Procurement Department

ADDENDUM # 6

To: File 1901-910-23-4878
QQ for: Villa Tranchese Fire Protection Improvements

1 MECHANICAL/ELECTRICAL BASEMENT PLAN - NEW
 ME-2B SCALE: 1/4" = 1'-0"

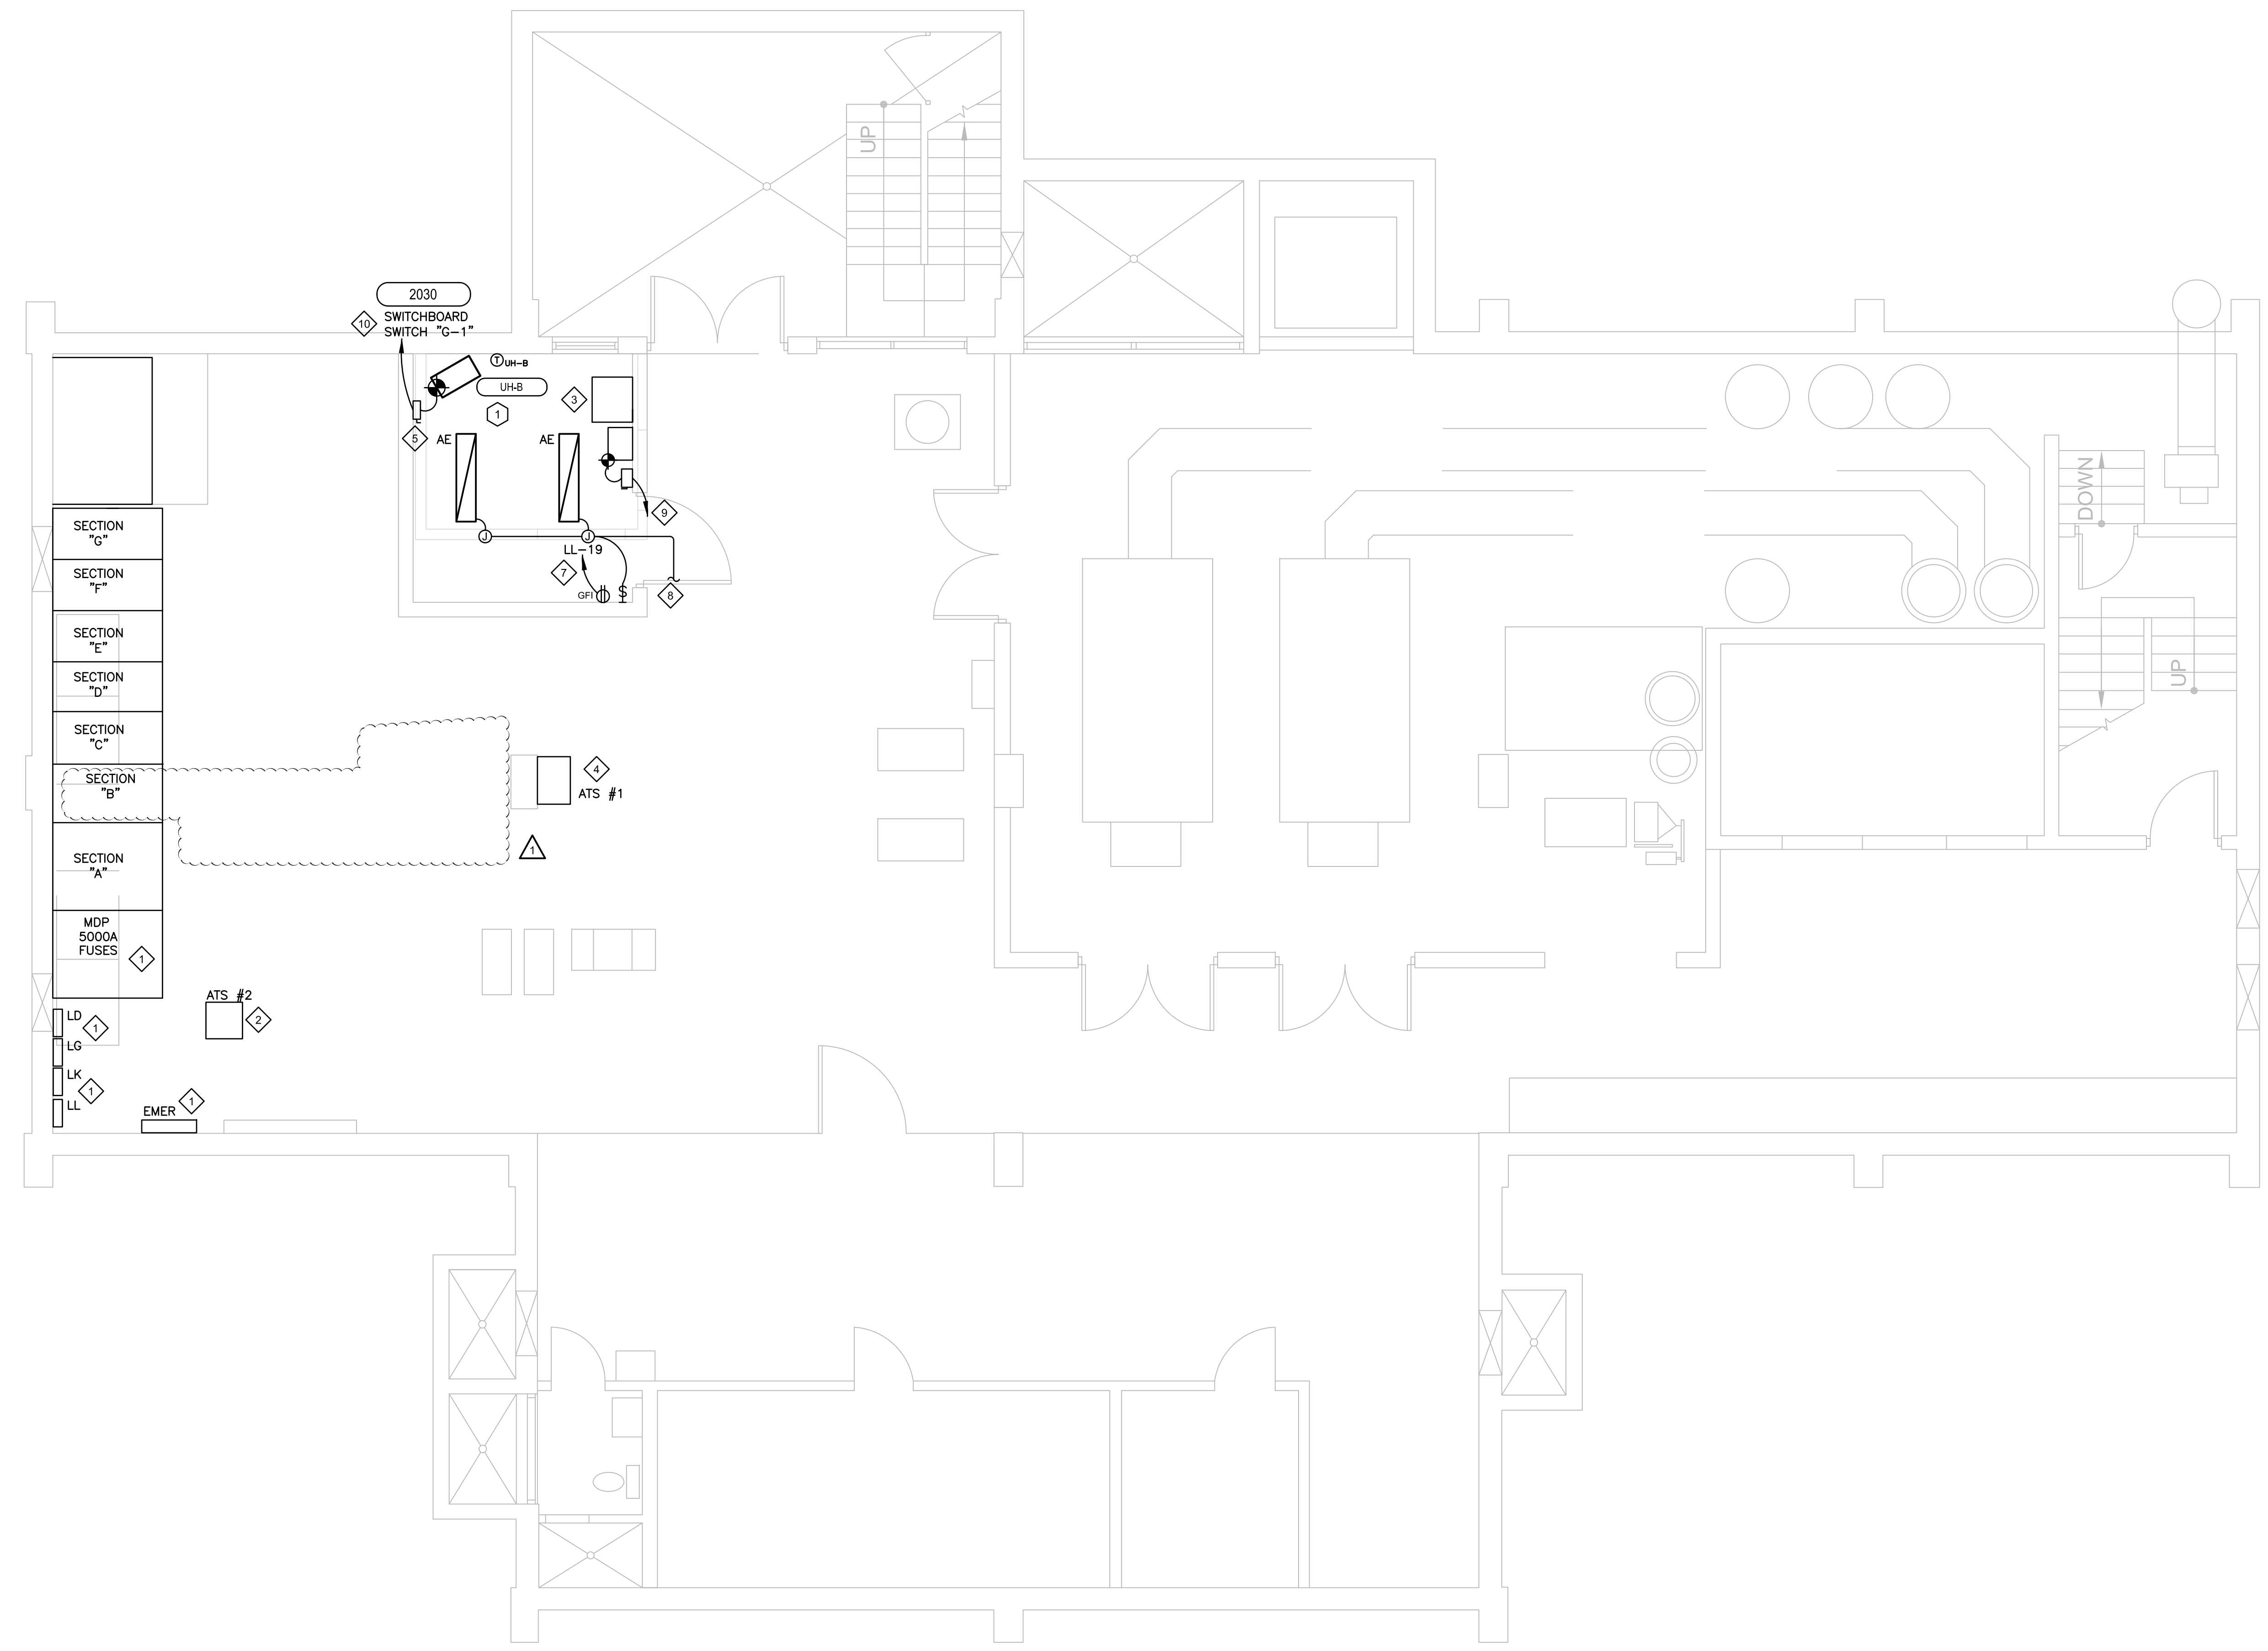
Question 1: My electrician just called and he is unclear about information on ME-7B / KN 11 (#4/0 wire going into a 400A disconnect) and ME-2B /KN 11 (a 5000A fully rated switch gear coming out of Section B), plus KN 6 is a bussed duct also coming out of Section B. The gist of the question is: What is inside of the 5000A switchgear and how does it relate to the gutter feeding the fire pump? Several of these details don't seem to match up, and because we are discussing a 5000A switchgear, the inside details are very important and expensive.

Answer 1: Refer to attached revised drawing ME-2B for clarification.
